SUBJECT: ISSUANCE OF AMENDMENT TO FACILITY OPERATING LICENSE NO. DPR-18

R. E. GINNA NUCLEAR POWER PLANT

Amendment No. 23
License No. DPR-18

SAFETY EVALUATION BY THE OFFICE OF NUCLEAR REACTOR REGULATION
SUPPORTING AMENDMENT NO. 23 TO FACILITY OPERATING LICENSE NO. DPR-18
ROCHESTER GAS AND ELECTRIC CORPORATION
R. E. GINNA NUCLEAR POWER PLANT
DOCKET NO. 50-244

Figure 6.2-1

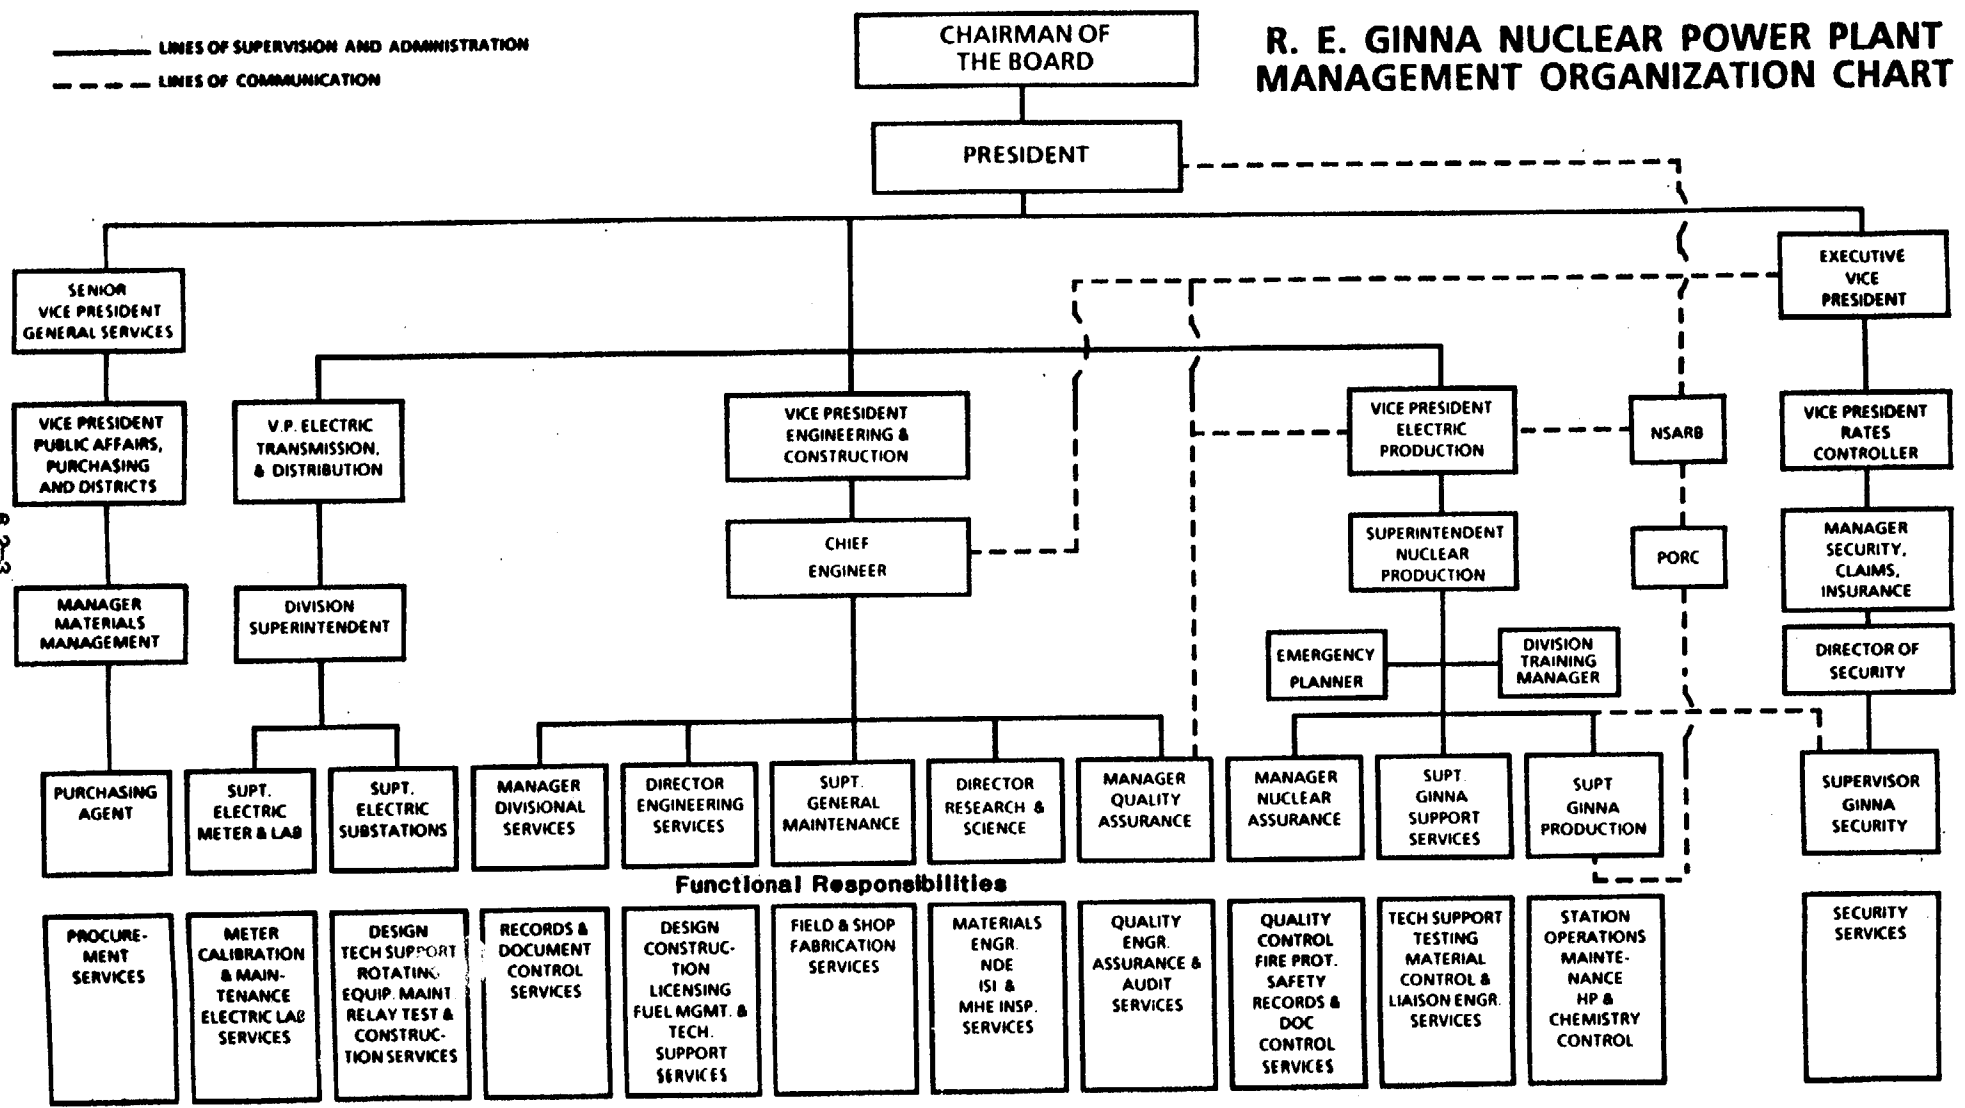
By letter dated December 17, 1986, Rochester Gas and Electric Corporation requested a number of changes to Section 6, "Administrative Controls", of the Technical Specifications for the R. E. Ginna Nuclear Power Plant. The requested changes are to the corporate organization, depicted on Technical Specification Figure 6.2-1, and to Ginna station organization, depicted on Technical Specification Figures 6.2-2, 6.2-3 and 6.2-4.

At the corporate level, the proposed changes reflect changes in the Engineering organization as a result of the retirement of the Assistant Chief Engineer and concurrent abolishment of the position, and changes to the Electrical Transmission and Distribution organization. In addition, there are several title changes. Figure 6.2-1 also would be modified to indicate the functional responsibilities of the various corporate positions. We have reviewed these proposed changes and we find that they are administrative in nature, that they do not adversely affect the corporate support to plant operations, and that the resulting organization meets the guidelines of Section 13.1.1 of the Standard Review Plan, NUREG-0800.

Figure 6.2-2

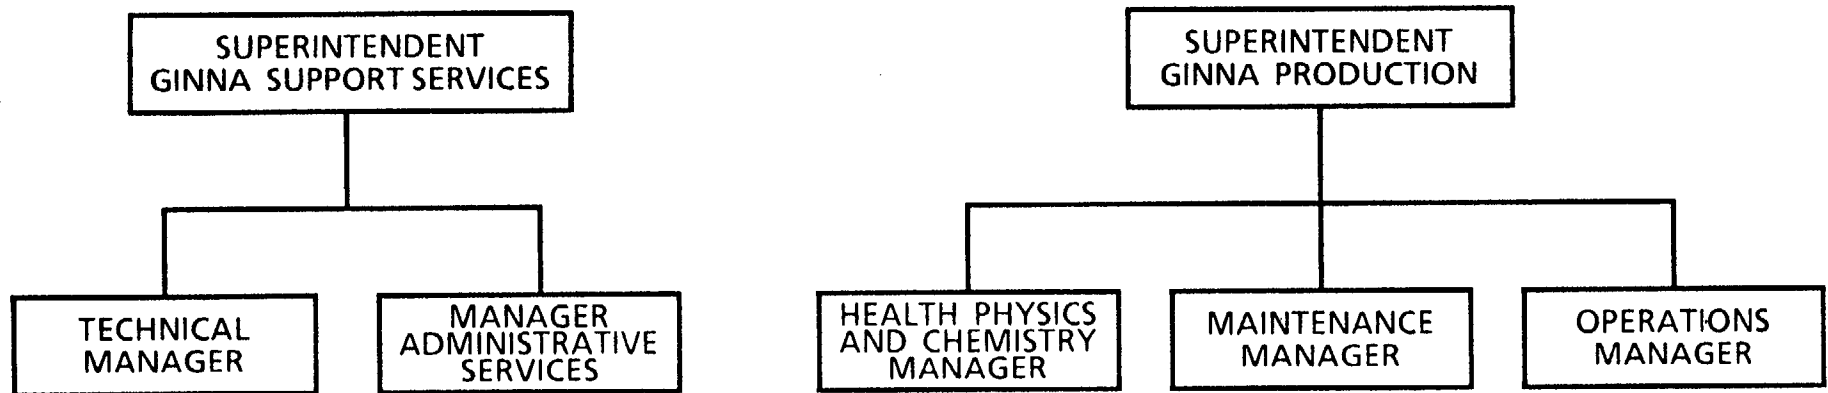
At the plant level, the title of the Materials Supervisor would be changed to Manager, Administrative Services and Figure 6.2-2 would be changed accordingly. This is a title change only and is acceptable. The title of Figure 6.2-3 would be changed from Administrative and Health Physics & Chemistry Section to Health Physics & Chemistry Section. This change corrects a typographical error and is acceptable. Figure 6.2-4 would be changed to show the Quality Control Inspection Supervisor reporting directly to the Nuclear Assurance Manager rather than through the Quality Control Engineer as depicted on the existing Figure 6.2-4. This change reflects a separation of the quality control responsibilities for work planning activities from the more traditional verification, inspection and surveillance activities. The change does not affect the quality control activities conducted at the station.
